Objection to the Planning application of Powerfuel Limited, to build a waste Incinerator in Portland Port and next to our existing Bunker facilities.

Impact Study Report

305301-09511 009-PBUK

PROJECT 305301-09511 - 009-PBUK: Impact Study Report

Figure 1- Location and Layout of the Portland Bunker Facilities and Proposed Power Fuel ERF

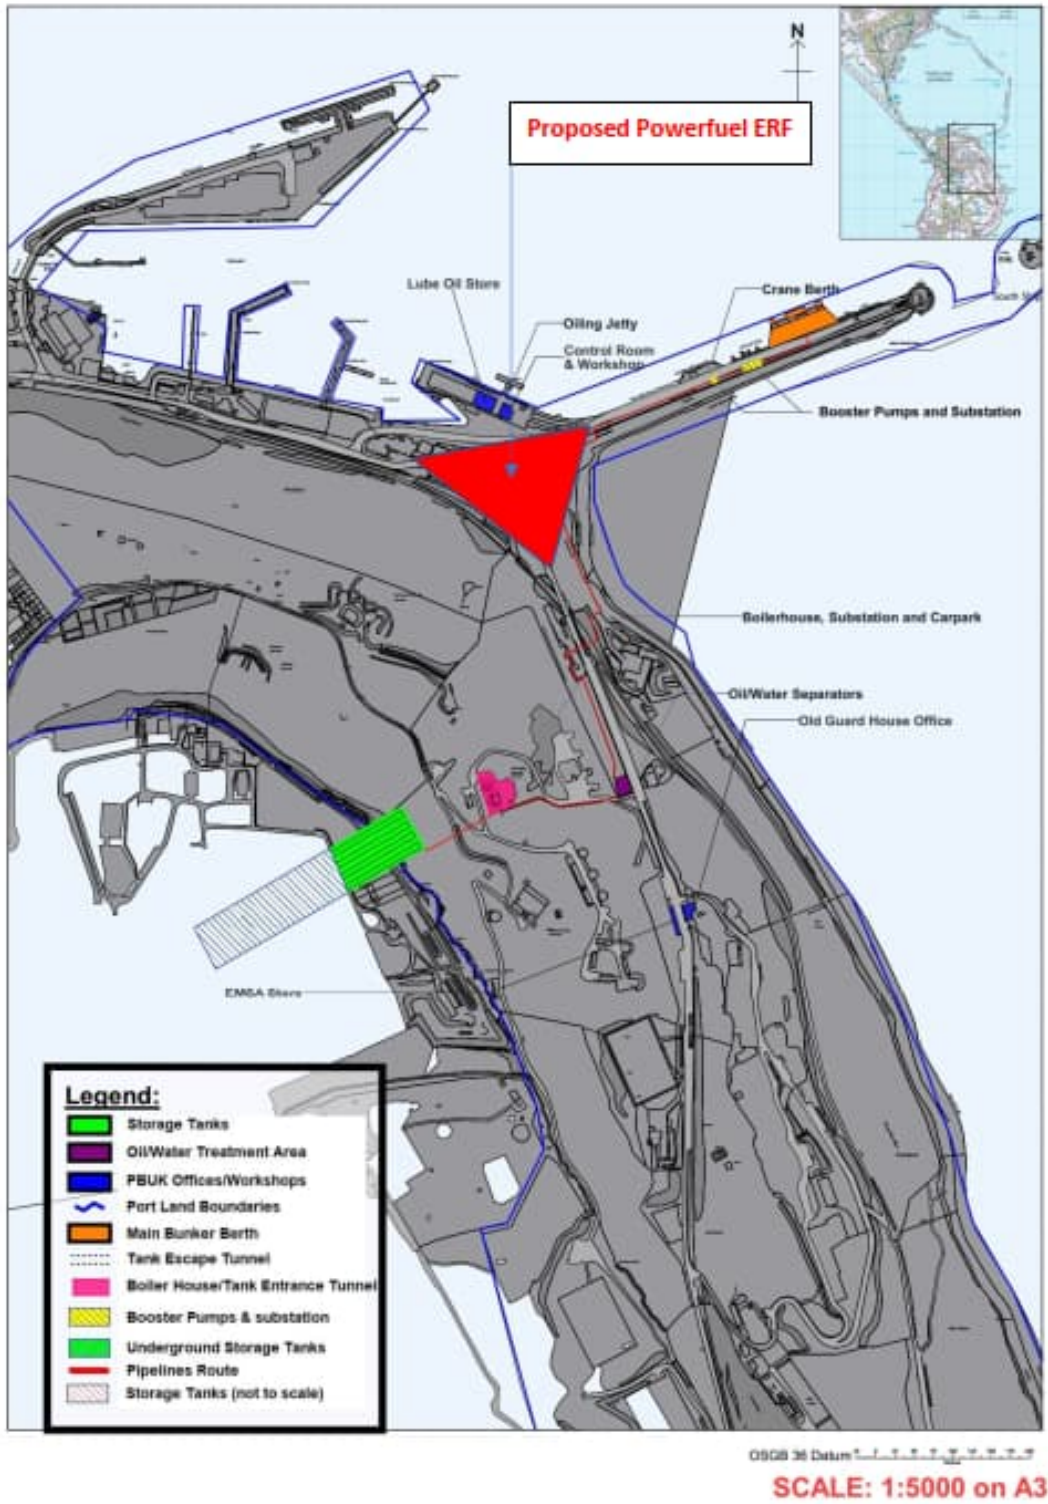
We would require Powerfuel to completely modify their footprint/facility layout, as the land they have leased or intend to lease from the Port is too small to contain such a unit and allow us the unrestricted access, we must have, to our facilities, pipelines and equipment.

PBUK are the nearest leasehold tenant to the proposed Incinerator, and this proximity is not restricted to one point where the plots "touch" but in actuality, there are many such points throughout the site.

Figure A1 – Powerfuel Ltd. Proposed ERF Layout

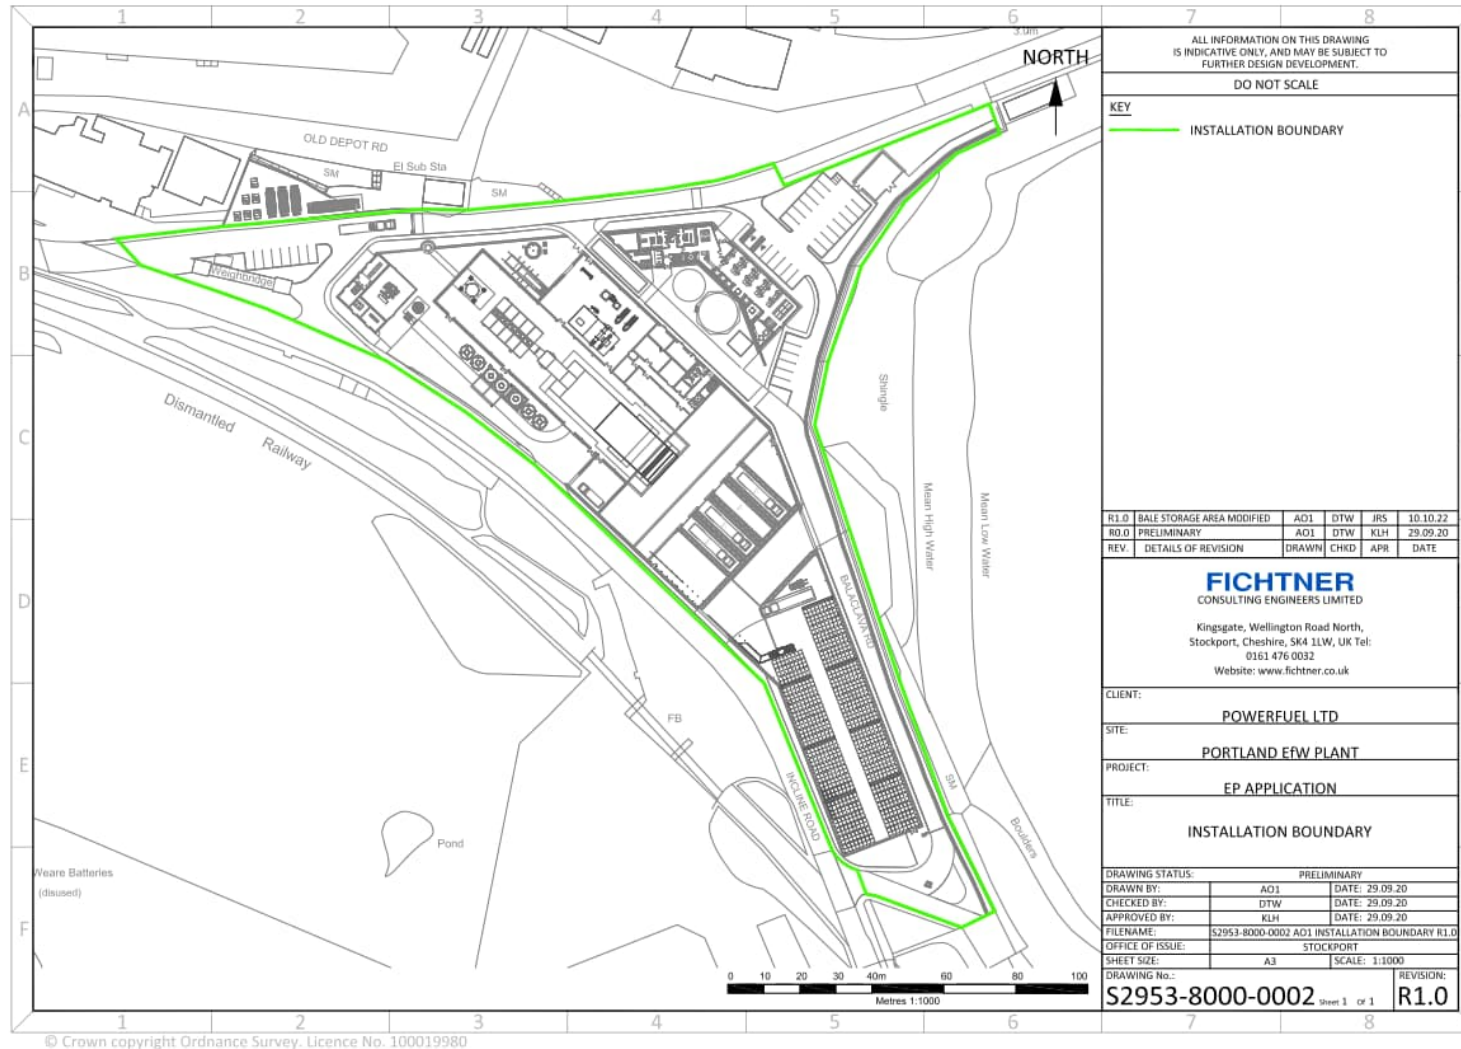
3. A road barrier is shown on what was Canteen Rd. this road (see Appendix A – Geo-environmental and Geo-technical desk study GEO-REP001 Rev. A 23 June 2020 – ARUP).	PBUK need to have access to their facilities at the Balaclava rd. in order to ensure that they can carry-out their day-to-day operations and conduct emergency response actions as required. Recommendation 3: The release of fluid from the bunkering lines along Balaclava Rd. is classified as a source of MAH and MATTE under the COMAH regulations 2015. The ERF proposed development restricts access to these lines. PBUK should define their expectations for operation and maintenance access for personnel and equipment to their facilities along Balaclava Rd. and make the request (to the ERF developer, Portland Port Ltd., and Planning Authority) that the design is modified in order to accommodate these requirements.	Spill from the pipelines along Balaclava Rd., has been classified as a source of MAH ^[4] and MATTE ^[2] .

4. Car parking is shown (5C) as an extension of Balaclava Rd. and all new parking at the	This means that vehicles will be entering and leaving parking spaces next to the bunkering pipelines and very frequently travelling along Balaclava Rd. with increased	Increase to safety and environmental likelihood with respect to existing HAZID ^[1] causes: 19/WP:4/1/16

Recommendation Number	Recommendation
1	The release of fluid from the bunkering lines along Balaclava Rd. is classified as a source of MAH and MATTE under the COMAH regulations 2015. The ERF proposed development restricts access to these lines. PBUK should raise the matter of loss of direct access to their facilities with the ERF developer, Portland Port Ltd. and Planning Authority and request a modified design that resolves the issue.
2	PBUK should request the ERF developer to offer legal guidance on their liabilities to PBUK and their employees should PBUK personnel and equipment need to operate within the boundary of the ERF.
3	The release of fluid from the bunkering lines along Balaclava Rd. is classified as a source of MAH and MATTE under the COMAH regulations 2015. The ERF proposed development restricts access to these lines. PBUK should define their expectations for operation and maintenance access for personnel and equipment to their facilities along Balaclava Rd. and make the request (to the ERF developer, Portland Port Ltd., and Planning Authority) that the design is modified in order to accommodate these requirements.

4	The release of fluid from the bunkering lines along Balaclava Rd. is classified as a source of MAH and MATTE under the COMAH regulations 2015. The ERF proposed development significantly increases vehicle movements in the vicinity of these lines. PBUK should raise the matter of how the design can be modified to remove the potential of vehicle impact with their facilities (resulting in potential release of bunkering fuel oil and consequential fire and environmental impacts), with the ERF developer, Portland Port Ltd., and Planning Authority.
5	The release of fluid from the bunkering lines along Balaclava Rd., the jetty, ship loading/unloading system or ship is classified as a source of MAH and MATTE under the COMAH regulations 2015. PBUK should raise the matter of the potential increased fire risk from vehicles, LPG storage and ERF facilities on their bunkering pipelines (resulting in potential release of bunkering fuel oil and consequential fire escalation and environmental impacts) and other facilities, with the ERF developer, Portland Port Ltd., and Planning Authority and request that a detailed fire risk assessment be carried out, covering PBUK work locations.
